7300 Cedar ave.
Takoma Park

Preliminary
Consultation
HAUP 37/3-08DDJ

From: Fothergill, Anne
Sent: Friday, May 08, 2009 12:34 PM
To: 'Chris Simpson & John Lorenz'
Subject: RE: 7300 Cedar Ave -- Siding Issue

PROPOSED REPLACEMENT
SIDING AND PROPOSED
WINDOW / DOOR CASING
TRIM MODIFICATION
29 APRIL 2009

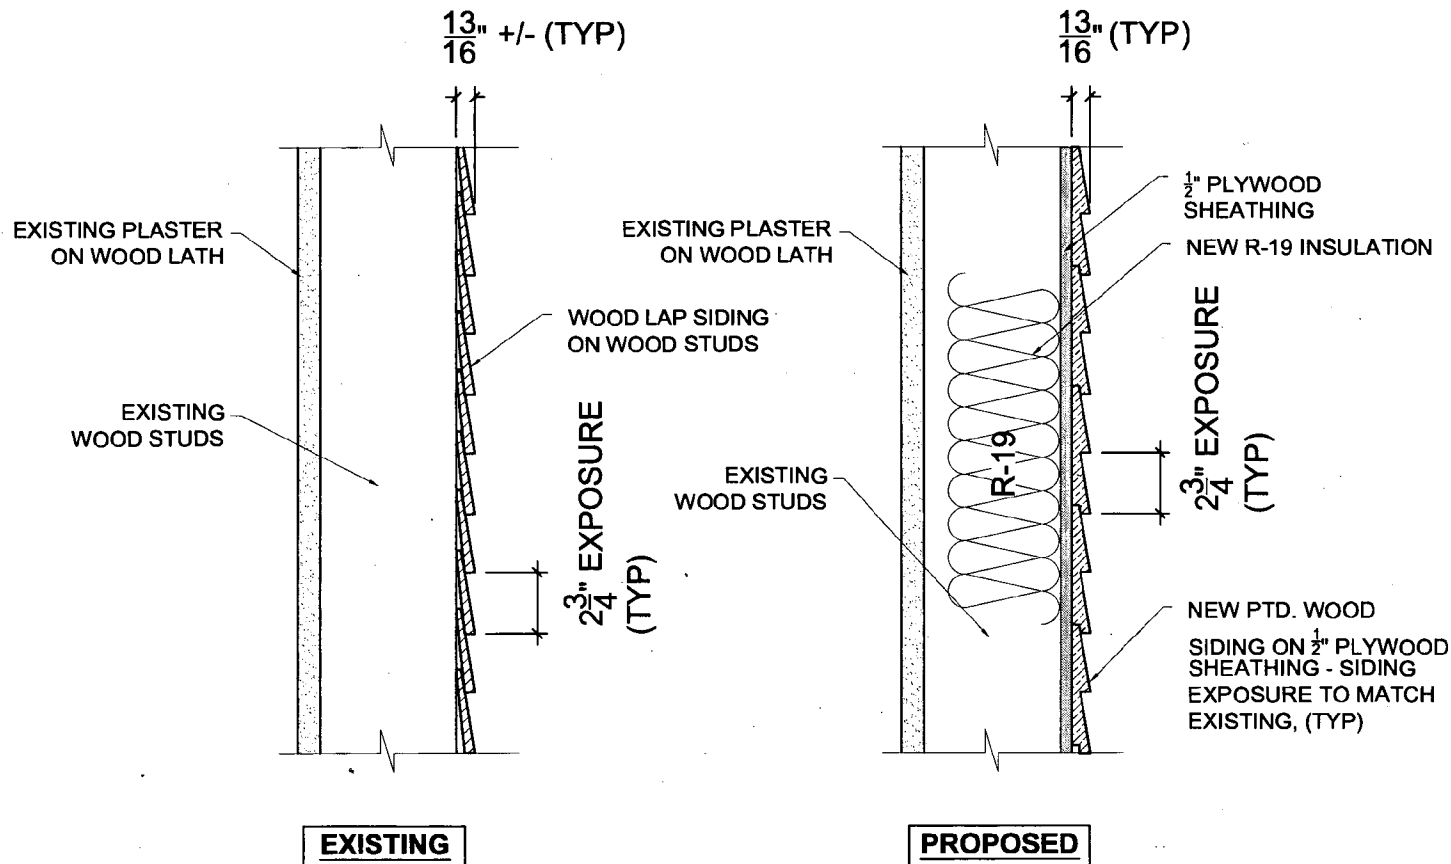
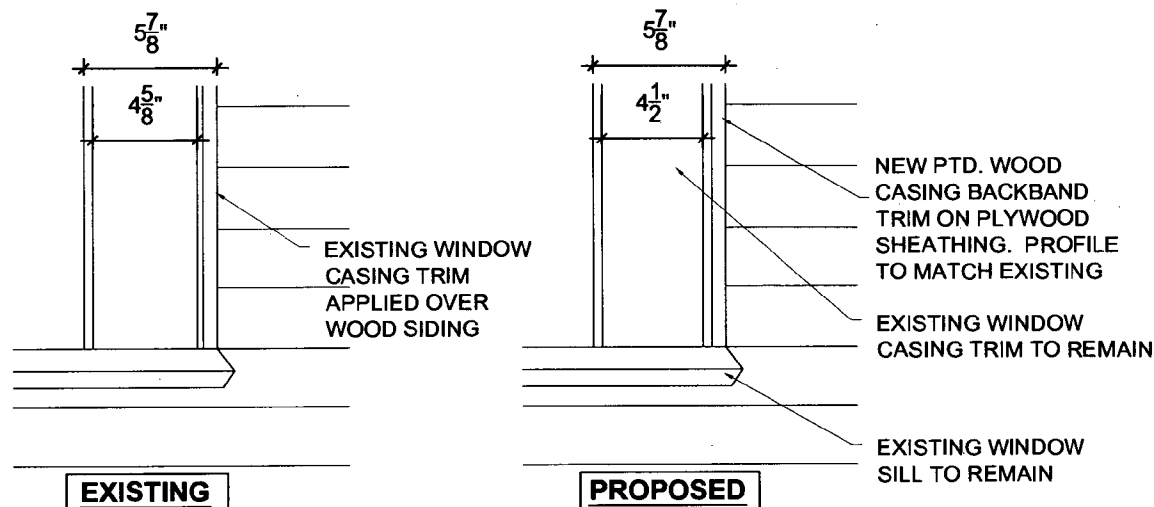
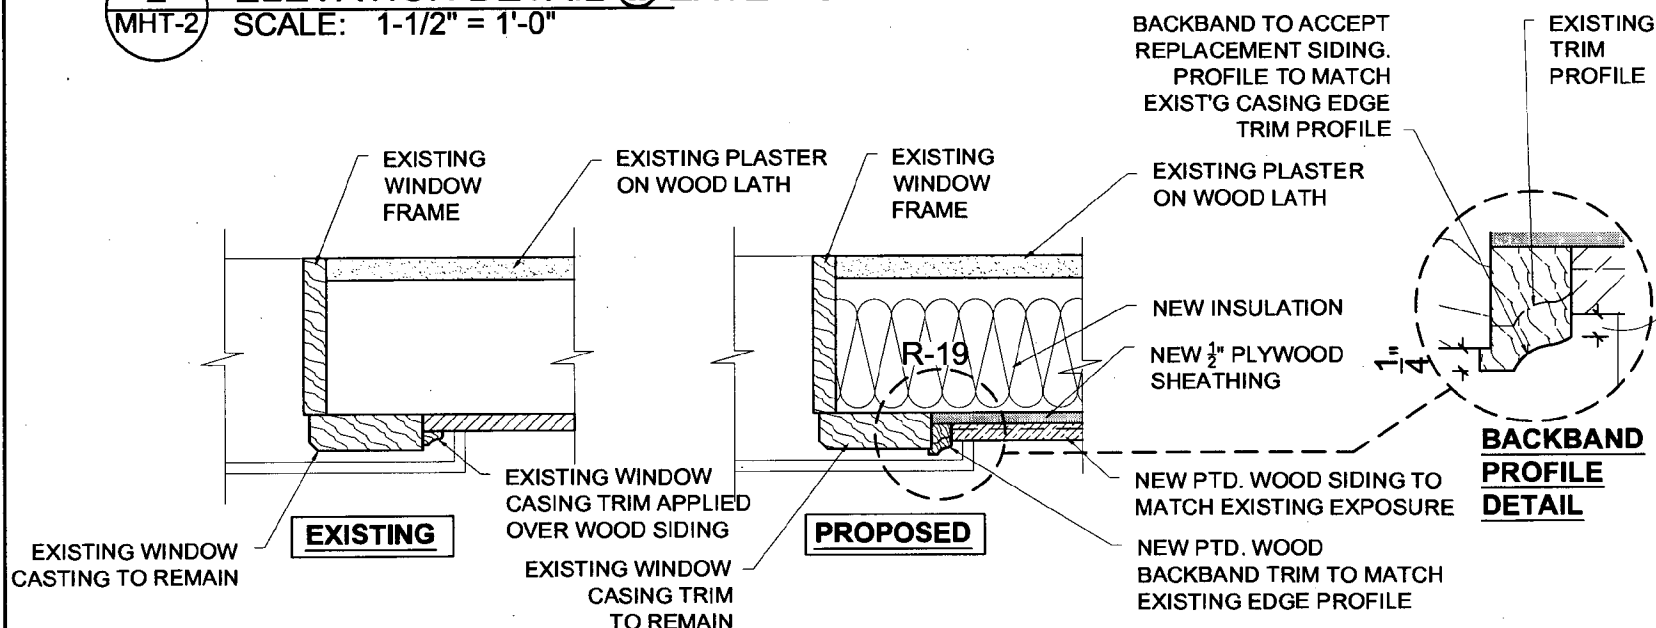
The asbestos siding has been removed from our house, as planned, to reveal the original clapboard siding. In our HAWP, we stated our intention to restore/repair this original siding. However, we have now learned that the original siding is nailed directly over the framing studs; there is no sheathing, which we are told is an unorthodox building method. This makes it inadvisable to blow in insulation, because without some kind of sheathing, the insulation is more likely to trap moisture in the wall cavity.

Our builder is recommending that we remove the old siding and apply 1/2" plywood sheathing and Tyvek house wrap. The original wood siding would not survive removal and re-nailing, especially after being stripped of the old lead paint, so the builder would mill new wood siding that matches the profile of the original.

This change would push the skin of the house 1/2" outward, bringing it nearly flush with the original window framing. To address this condition, our architect is proposing that we mill a backband to surround the window trim. The backband would be L-shaped, with a corner profile matching the existing window trim profile. This would not affect the front elevation of the house, as we are not changing the shiplap siding that was added in 1939.

To sum up: We need to replace the siding in-kind and to add custom-milled trim to preserve the window profiles. Please let us know if this change is acceptable under the terms of our HAWP.

Thanks for sending the plans for our review. I am not sure if you have already talked to Scott about this because I know you and he talked when I was away. And I am not sure if you have consulted with MHT, which you would need to do if you are still pursuing tax credits. But, Scott and I met and determined that this would constitute a change to your approved HAWP and would require HPC review. However, we would recommend that before you submit for a revision you perhaps consult an expert in historic restorations and explore other alternatives to minimize impacts to the historic fabric. Insulation is a big issue in restorations and perhaps there is another solution. Also, we would recommend that if you do decide to propose the new sheathing/Tyvek, that you retain as much of the old siding as possible rather than holistically replacing it with new siding. You don't necessarily need to strip the lead paint and since you think that will be hard on the wood, maybe you would consider that.

- 1) Discuss this with MHT if you are still hoping to get tax credits.
- 2) Ask your architect or builder to provide us a section showing a profile of the existing siding and window trim and what is proposed. We will take it to the HPC as a staff item and see what they say.
